ADDENDUM

Client: North Pike Library District
 Project Name: Reroof Existing Building
 Project Number: 6613
 Addendum Number: 2
 Issued: 04/25/25

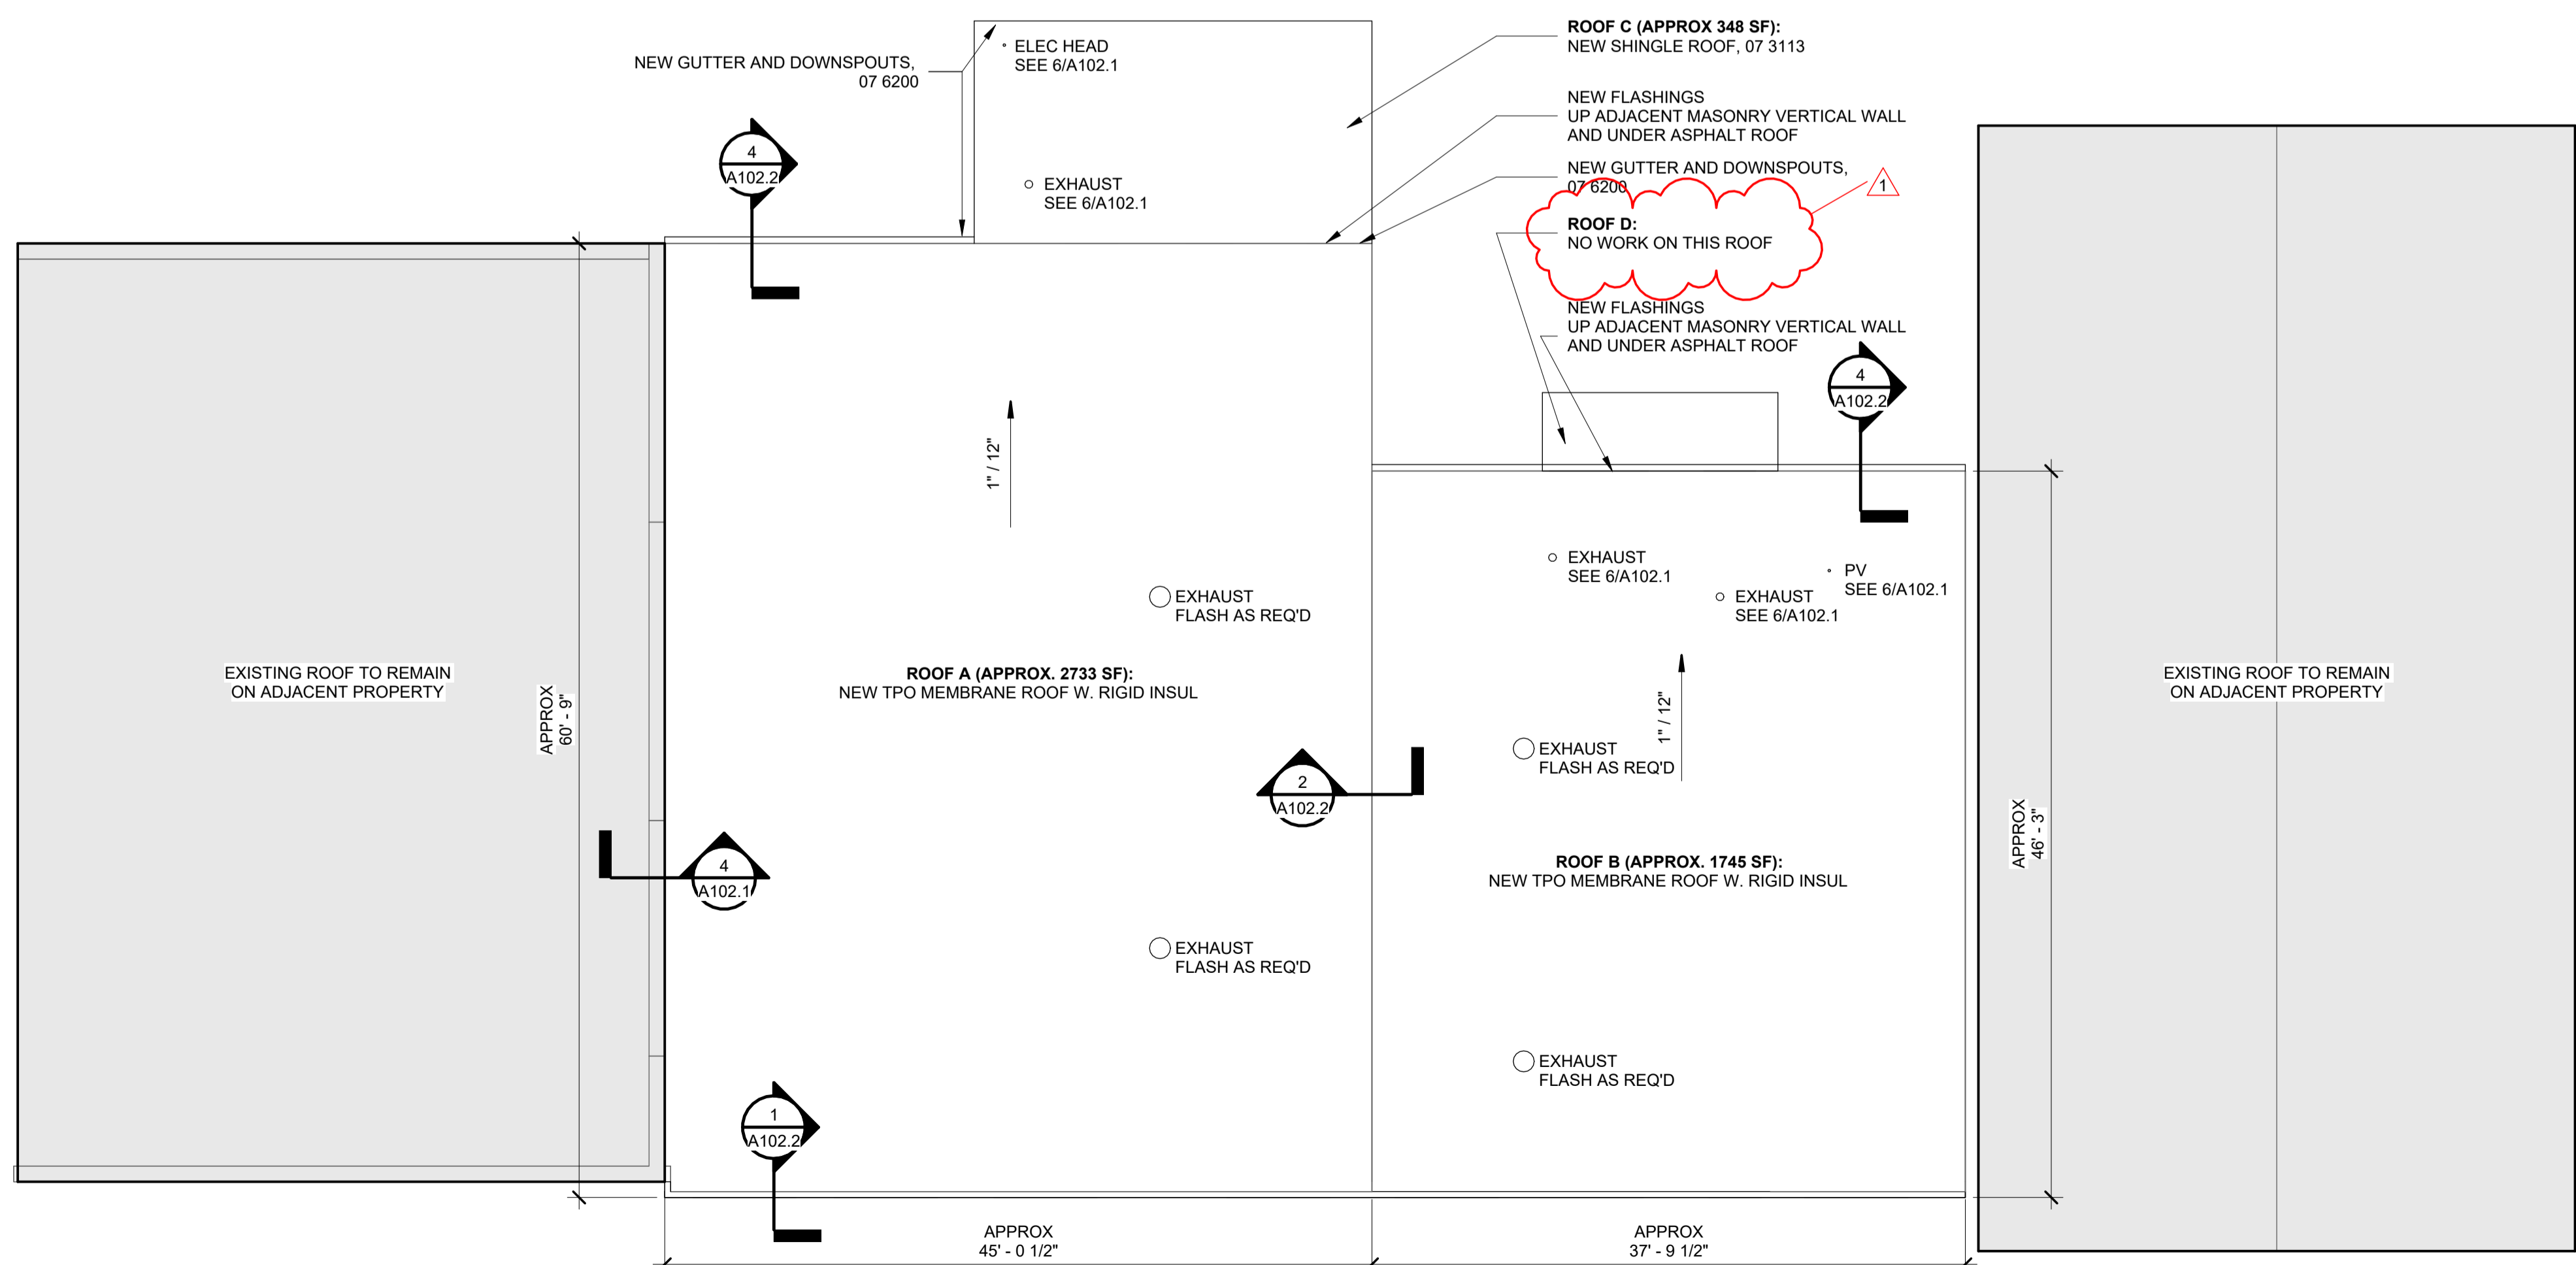
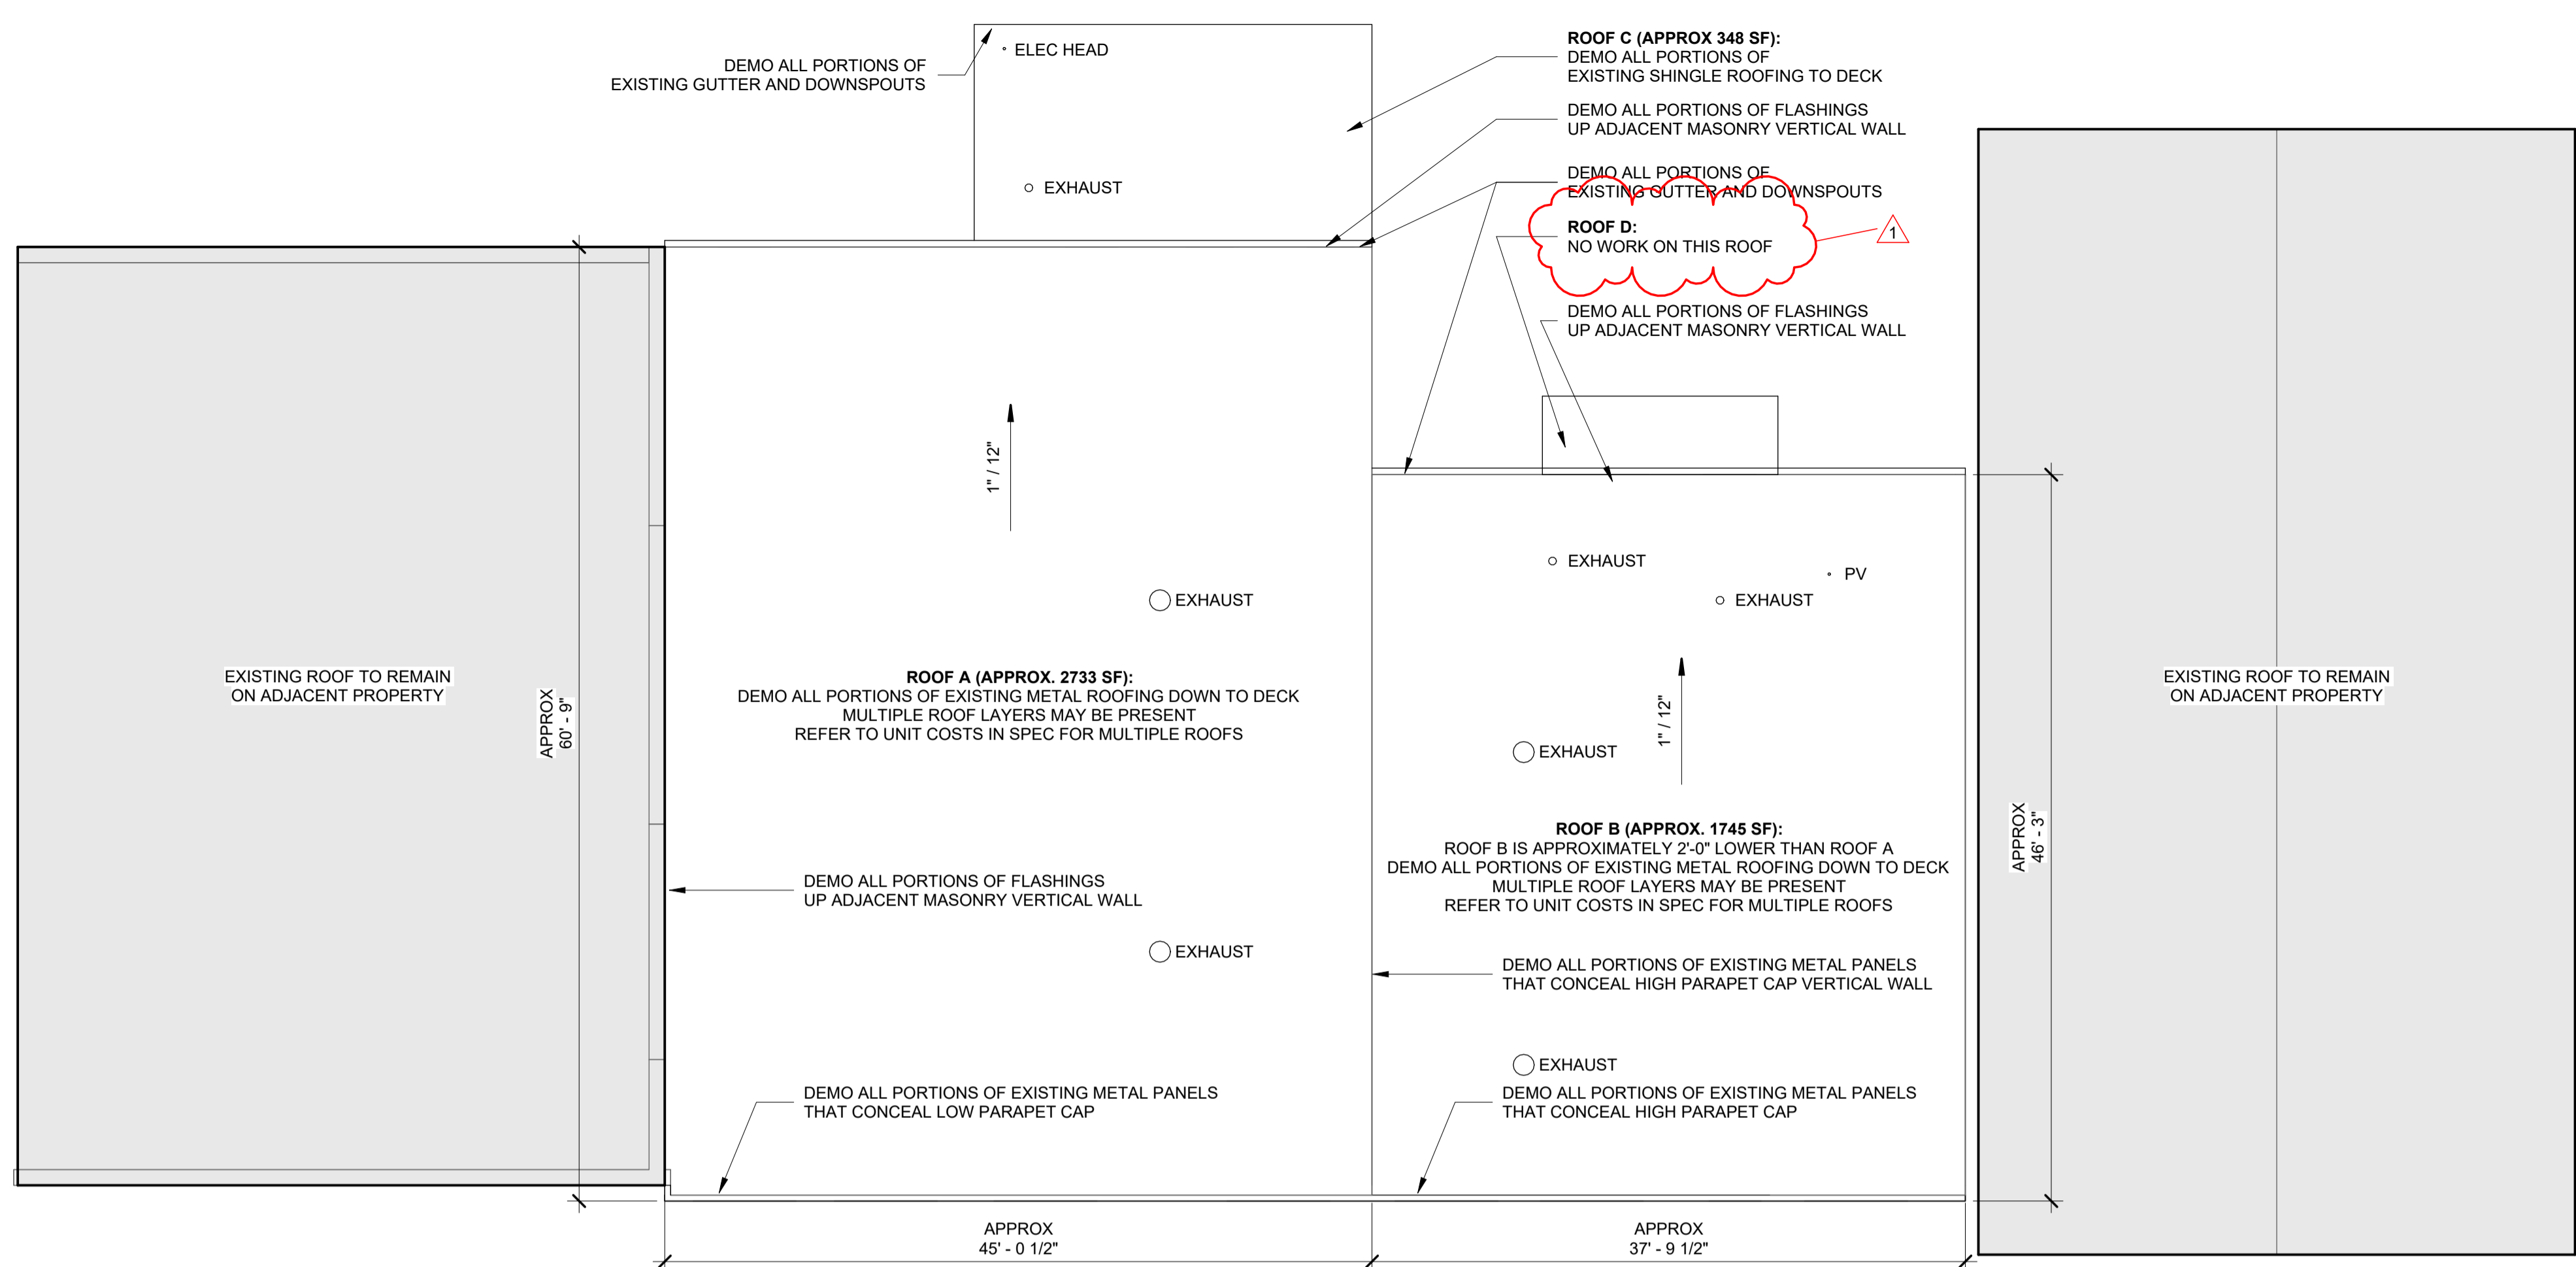
ITEM	DESCRIPTION	NOTES
CLARIFY		
Detail 4/A102.1	Clarify	This detail shall be used for installing flashing against the existing wall of an adjacent property to the east. There is an approximate 4" to 6" gap between the existing east wall of the adjacent property and the building being reroofed. The new insulation shall extend to within 1/2" of the existing adjacent all. The new roof membrane will span this gap and be flashed up the existing adjacent wall.
SPECIFICATIONS		
Section 00 4100 - Bid Form	Replace	Replace with attached revised section
Section 01 2200 - Unit Prices	Replace	Replace with attached revised section
Section 07 4213 - Metal Wall Panels	Replace	Replace with attached revised section
DRAWINGS		
Sheet A102.1	Replace	Replace with attached revised sheet.
